# HISTORIC AND DESIGN REVIEW COMMISSION

**HDRC CASE NO:** 2021-410  
**ADDRESS:** 126 POTOMAC ST  
**LEGAL DESCRIPTION:** NCB 585 BLK 3 LOT 7 & 8  
**ZONING:** RM-4, H  
**CITY COUNCIL DIST.:** 2  
**DISTRICT:** Dignowity Hill Historic District  
**APPLICANT:** Felix Ziga/Ziga Architecture Studio PLLC  
**OWNER:** Brett Henneke  
**TYPE OF WORK:** Construction of a 2-story residential structure with a detached accessory structure  
**APPLICATION RECEIVED:** August 13, 2021  
**60-DAY REVIEW:** Not applicable due to City Council Emergency Orders  
**CASE MANAGER:** Edward Hall

**Historic and Design Review Commission**  
***Design Review Committee Report***

## **HENNEKE RESIDENCE – 126 POTOMAC – NARRATIVE**

PROPOSED SITE/ROOF  
PLAN

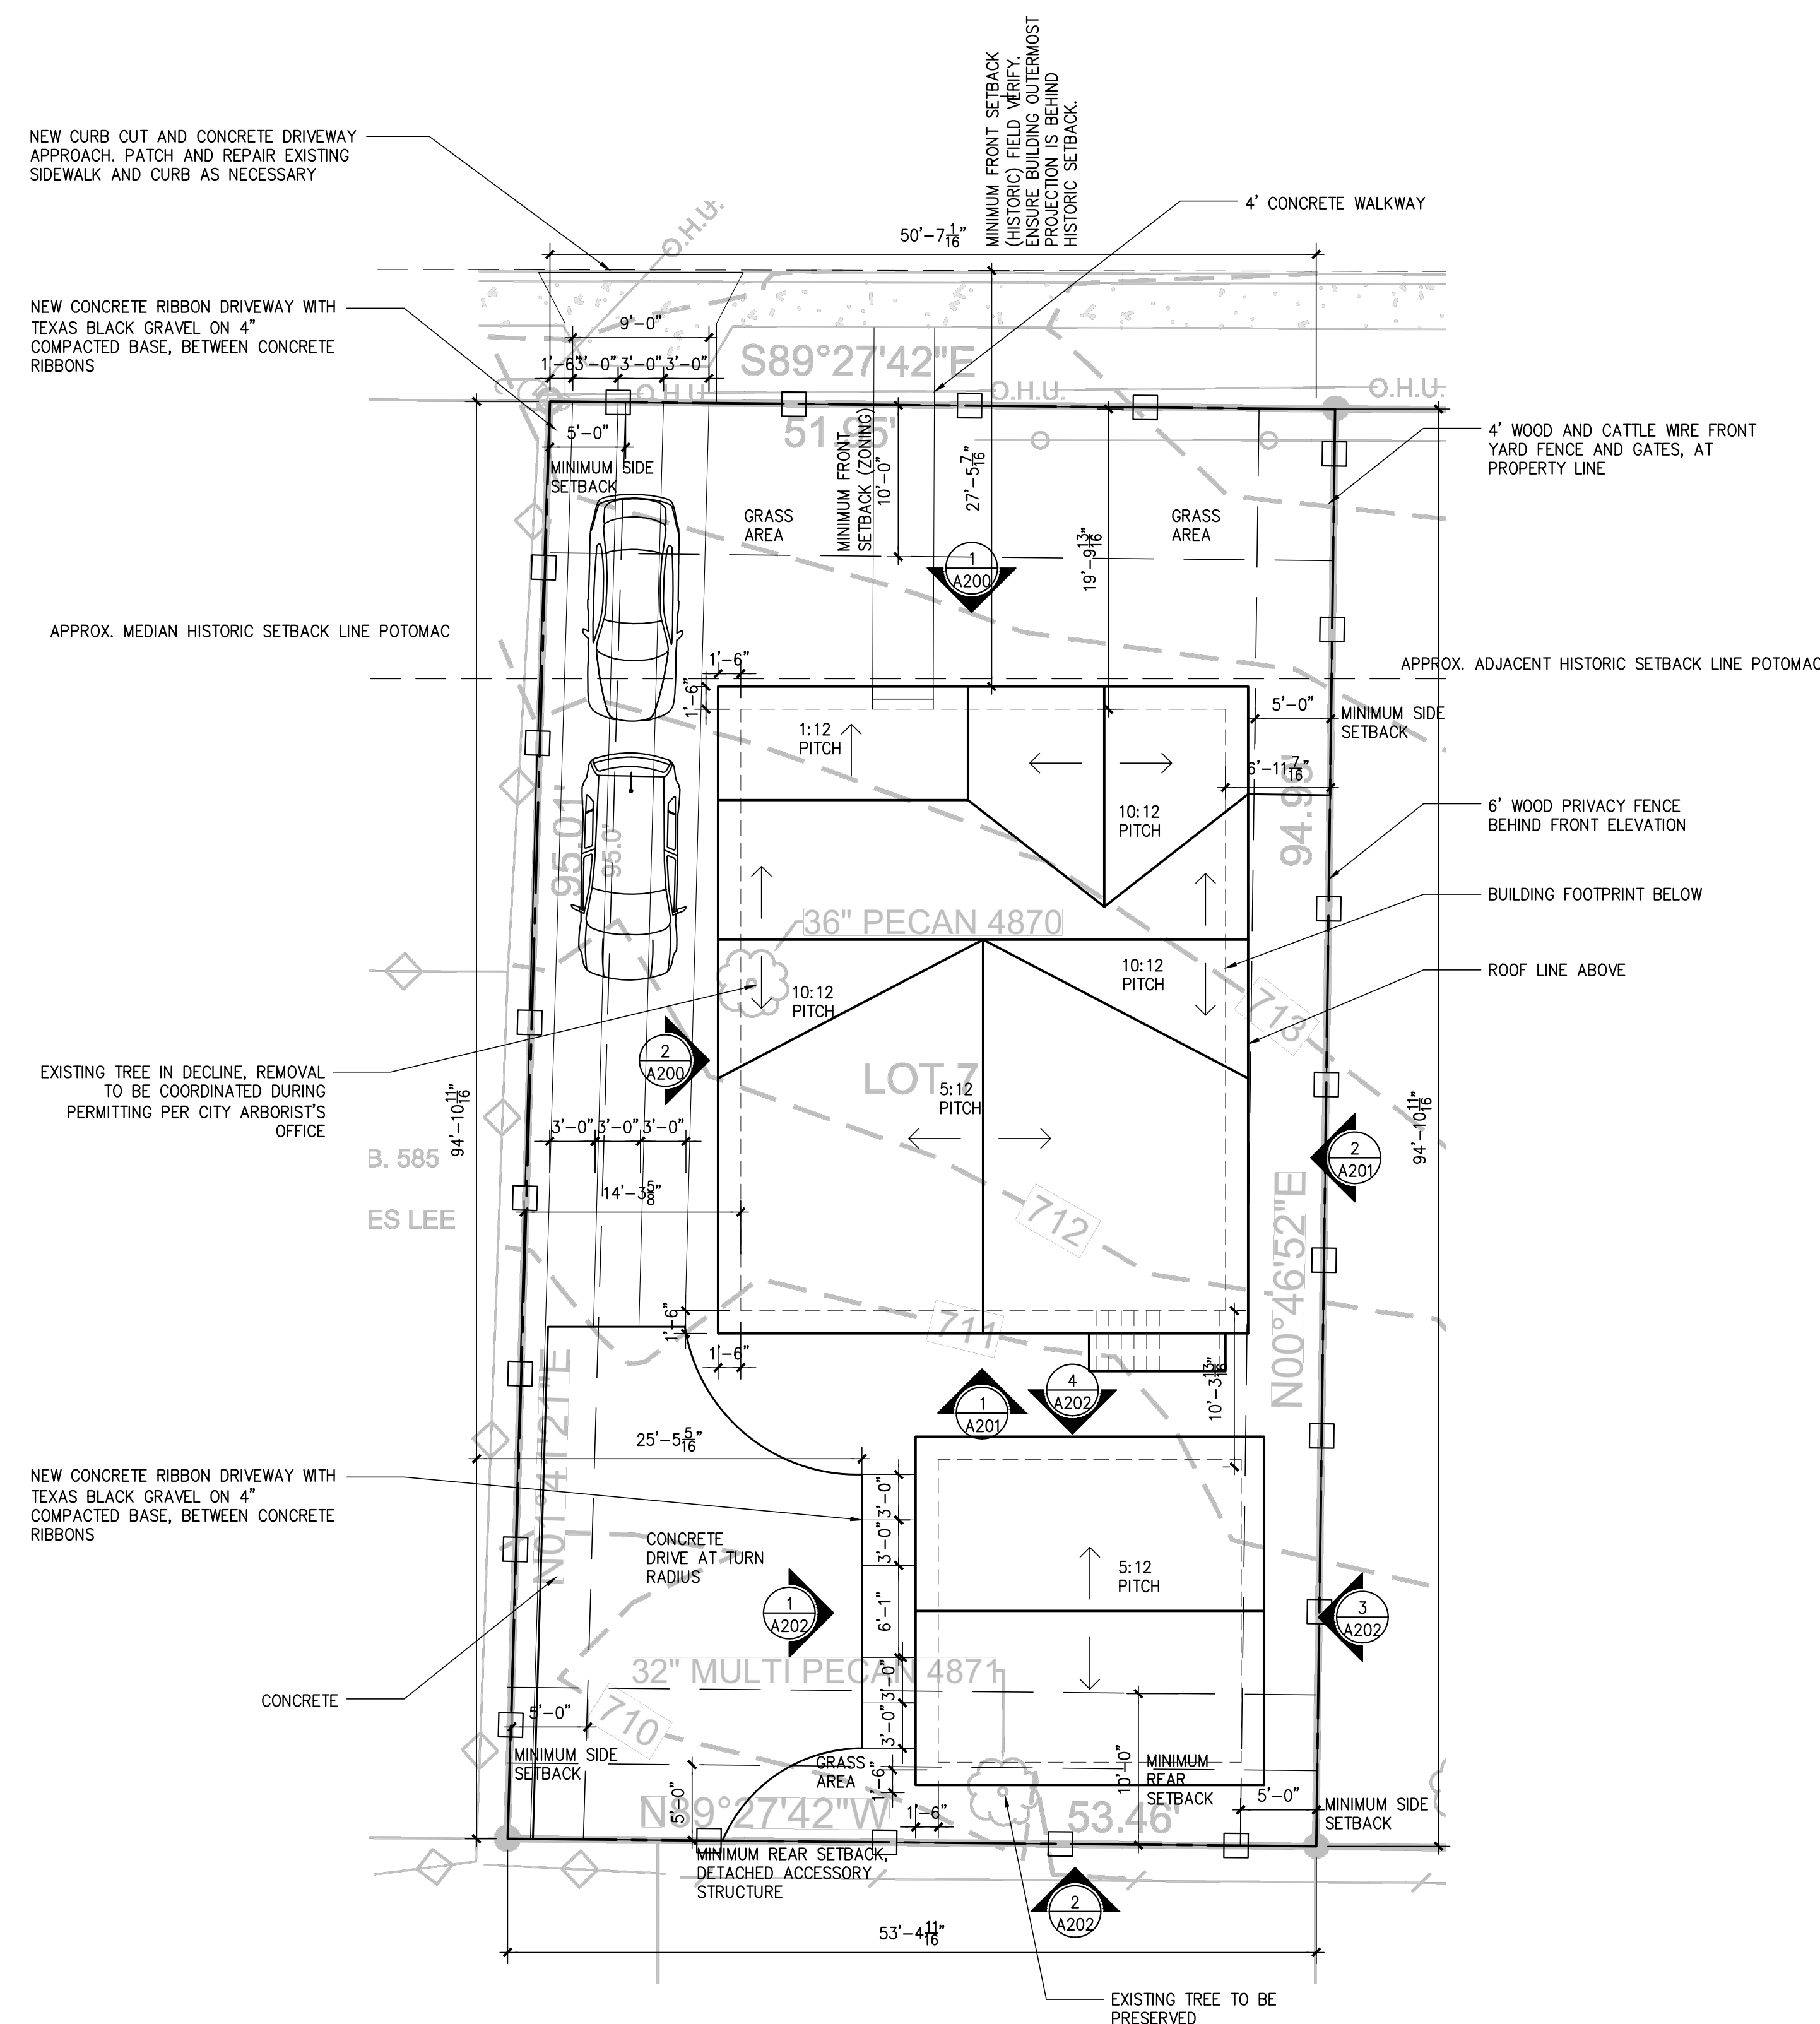
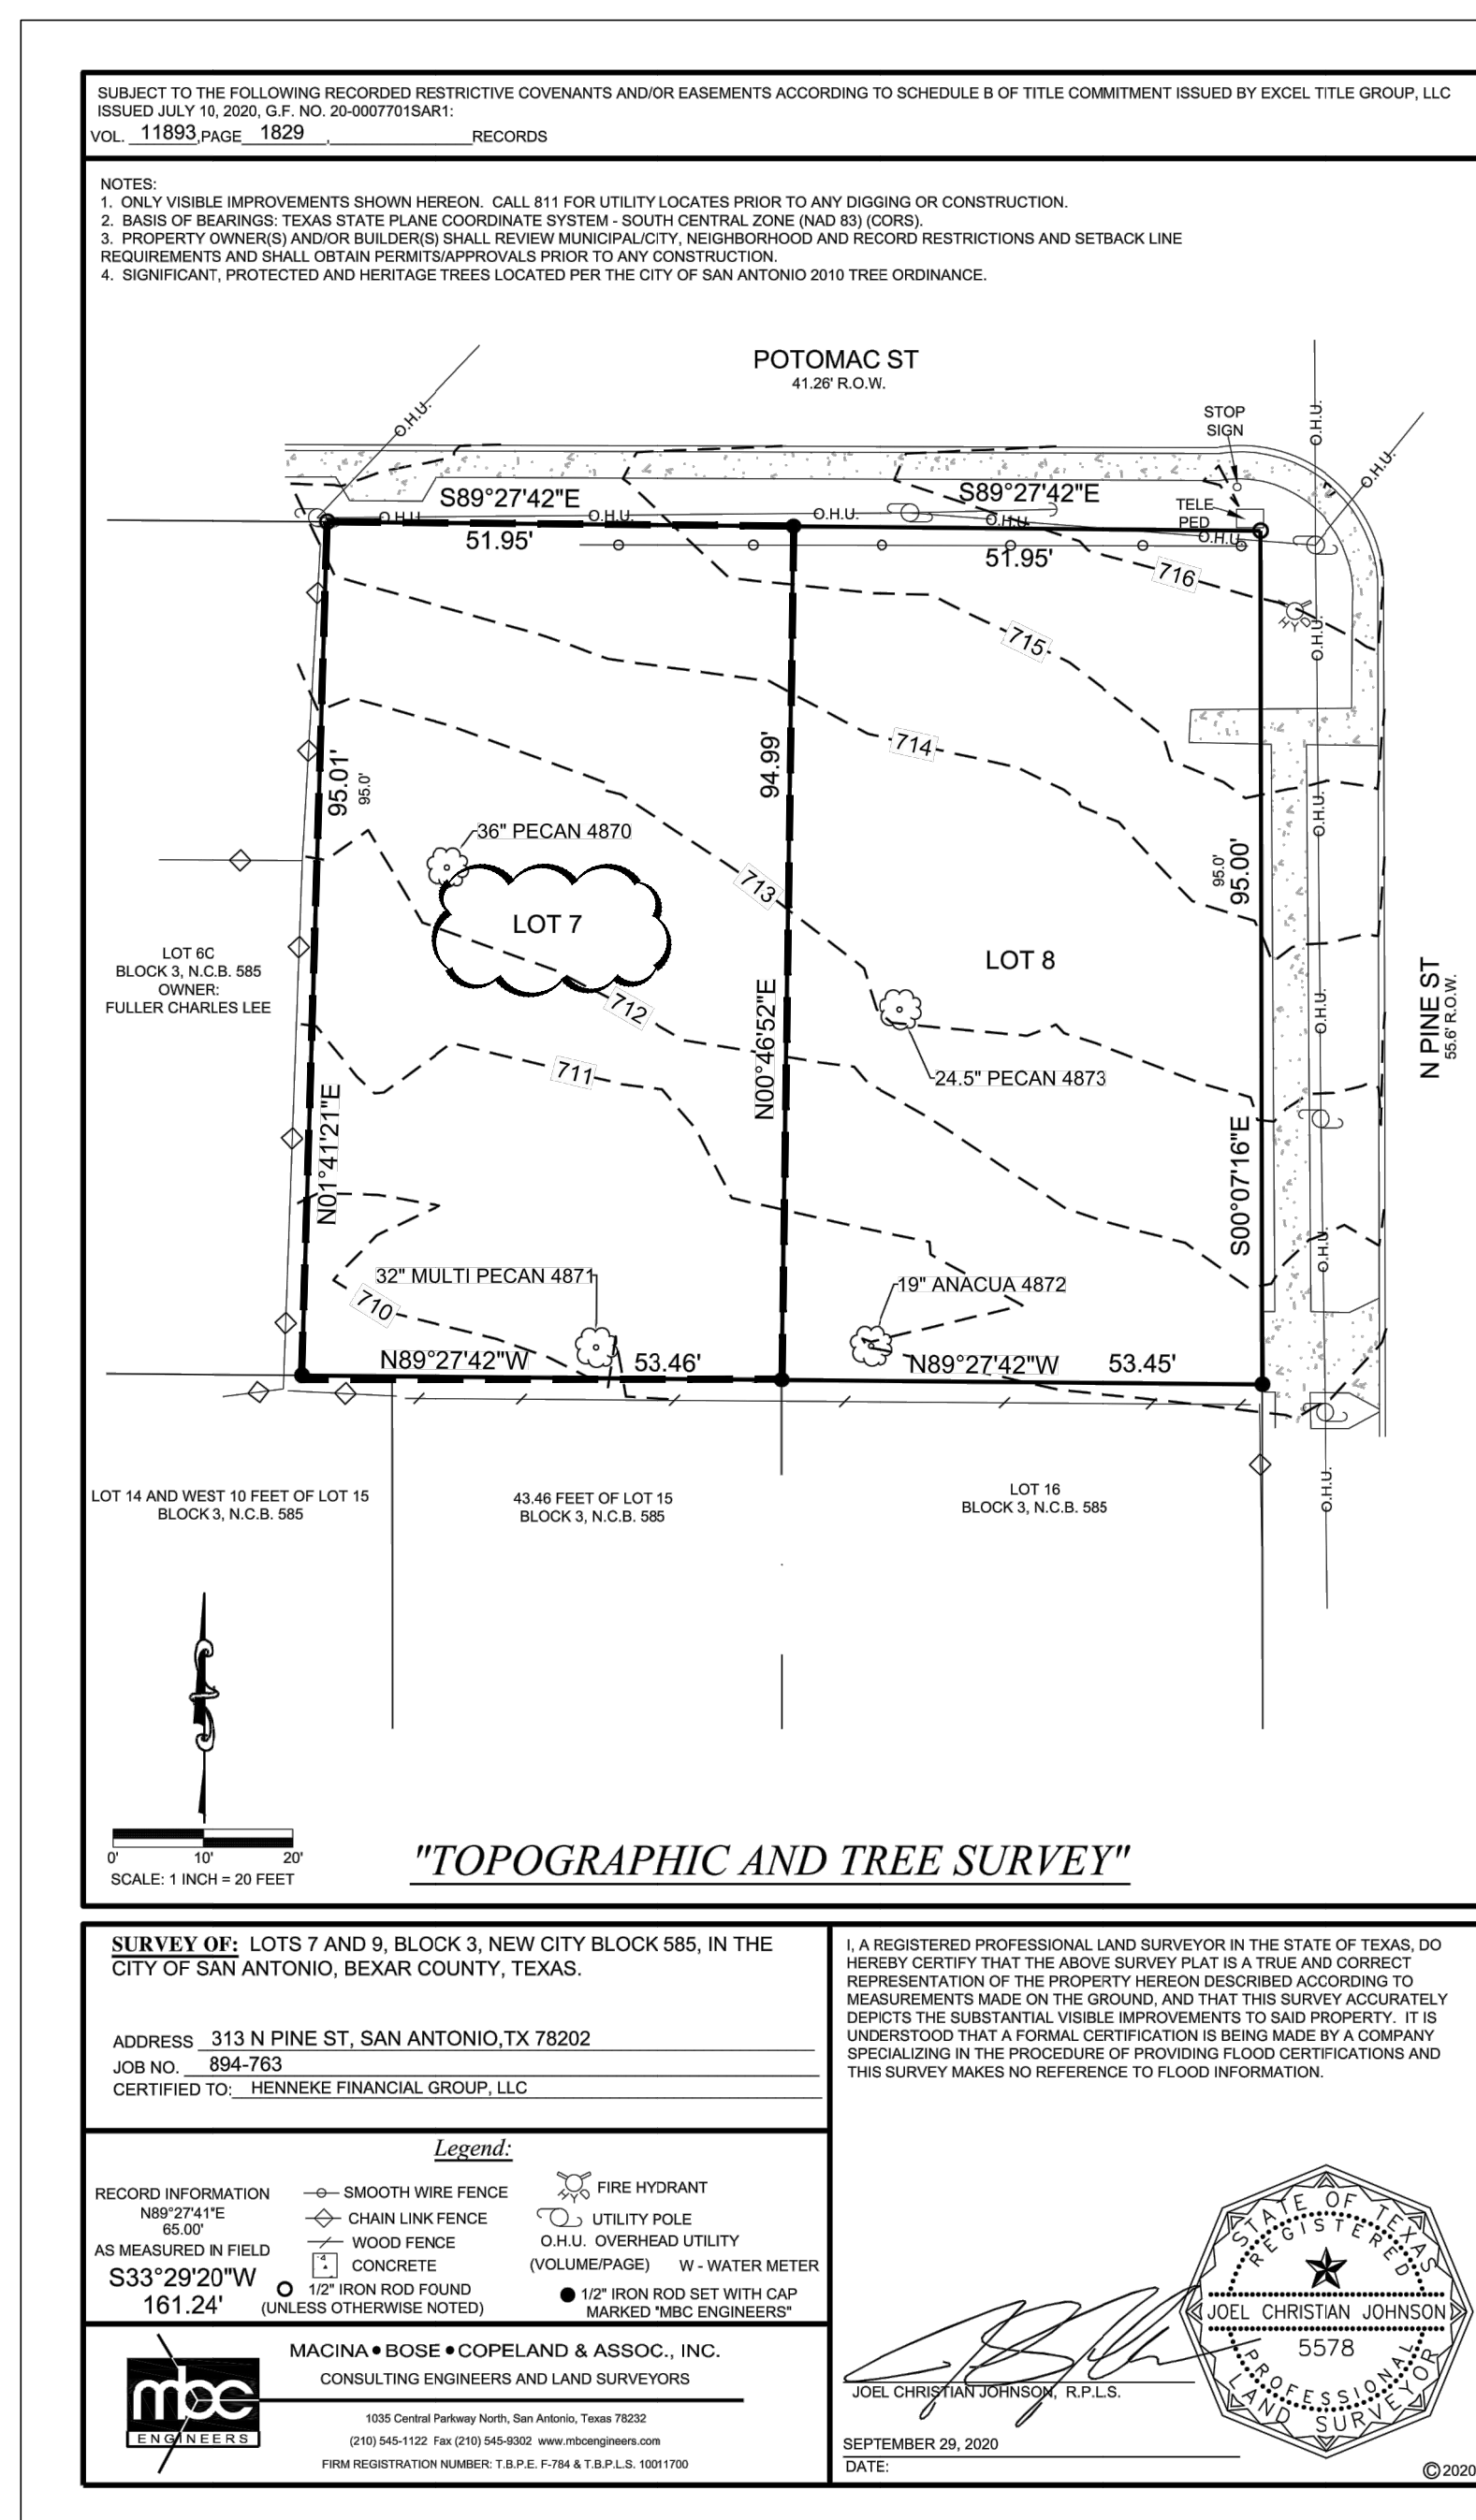
- d. **SETBACKS & ORIENTATION** – According to the Guidelines for New Construction, the front facades of new buildings are to align with front facades of adjacent buildings where a consistent setback has been established along the street frontage. Additionally, the orientation of new construction should be consistent with the historic examples found on the block. The applicant has proposed a setback that is to be generally aligned with the front setback of the adjacent historic structure at 122 Potomac. Staff finds that a setback that is equal to or greater than that found historically at 122 Potomac to be appropriate and consistent with the Guidelines.

- t. FENCING – The applicant has proposed front yard fencing with a driveway gate at the property line. Staff finds that the proposed front yard fencing should turn at the driveway with a driveway gate being located behind the front façade of the house.

- i. That the front setback to equal to or greater than that of the historic structure at 122 Potomac, and that field verification be required prior to the issuance of a COA, as noted in finding d.
